## ADDENDUM NO. 1

December 8, 2025

TANG HALL LABORATORY  
FIT-OUT

**A-920R**

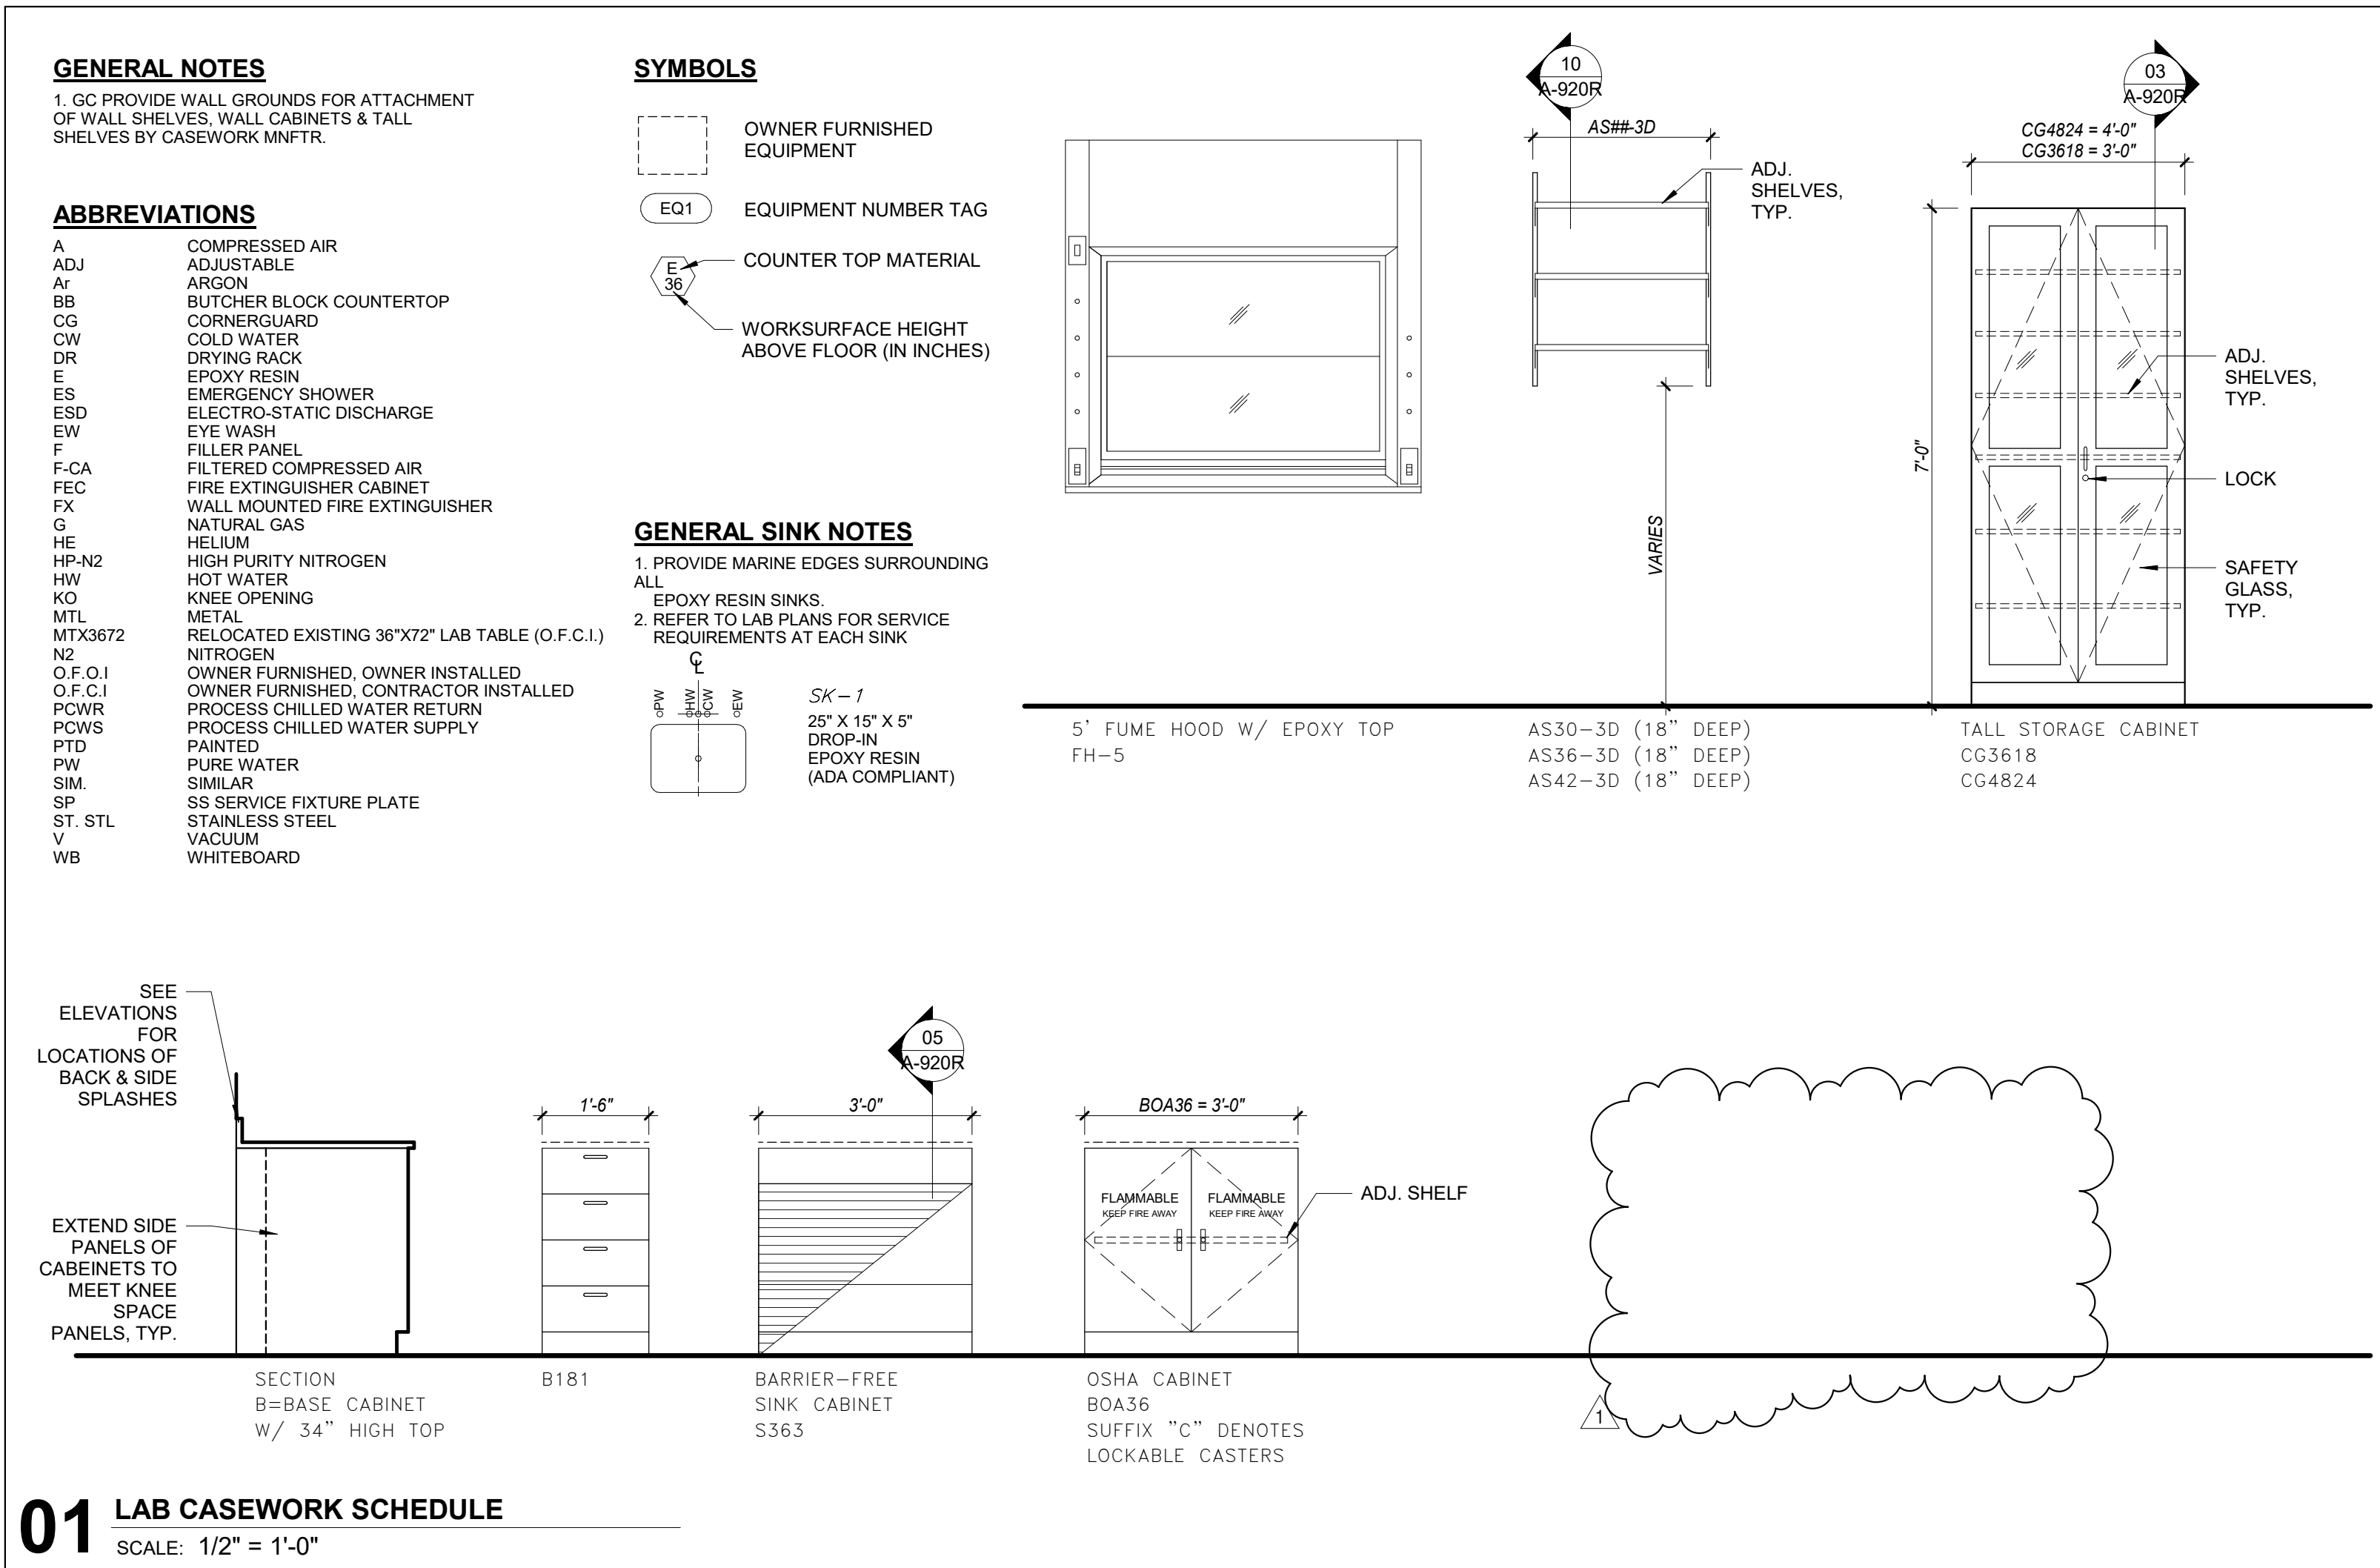
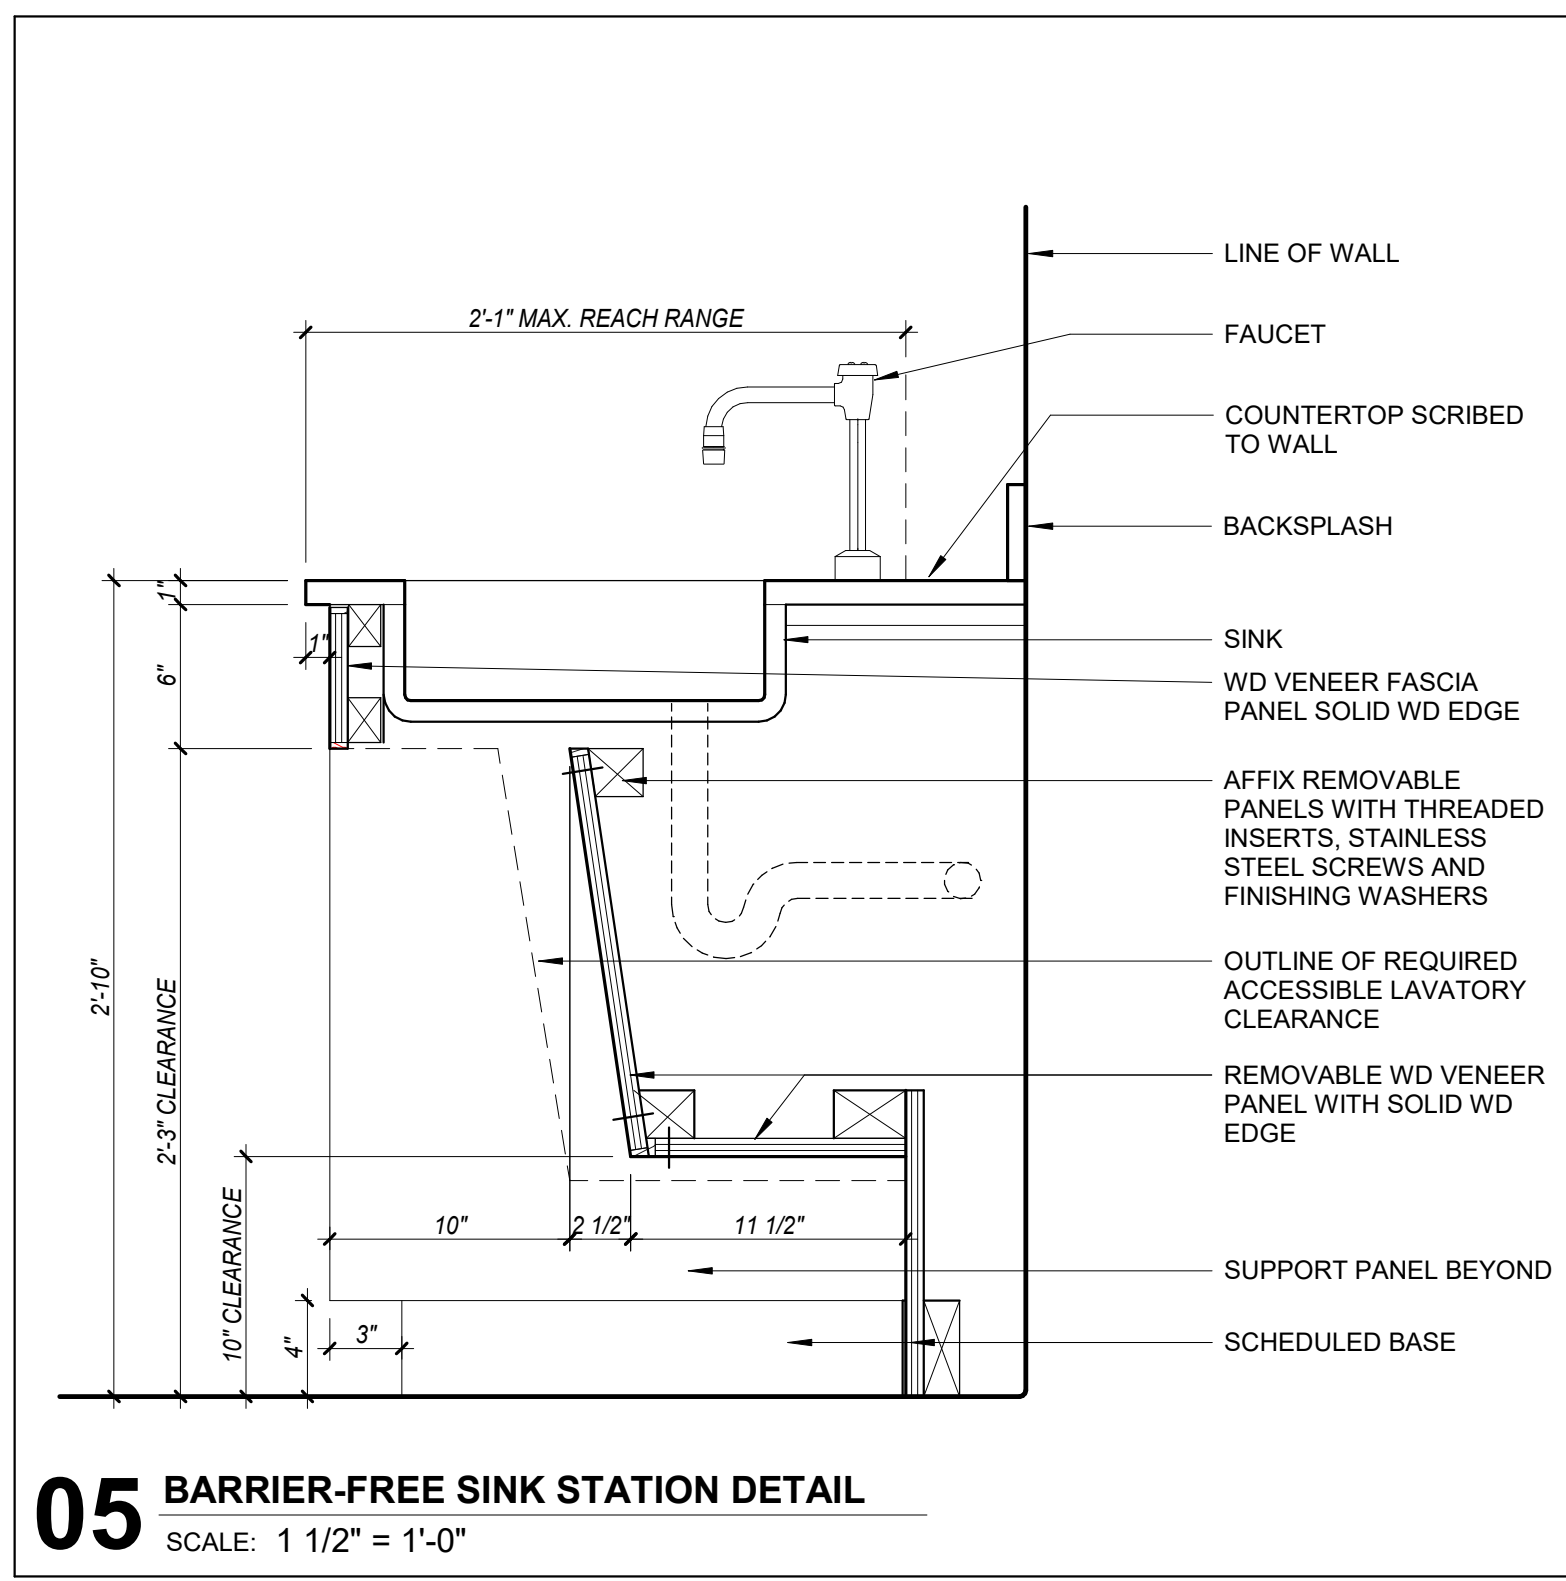
At new whiteboard detail:

**DELETE** new whiteboard detail. See Item 12 for description.

Item 19. Drawing A-920R, Movable lab table

**DELETE** movable table detail from lab casework schedule. See Item 16 for description.
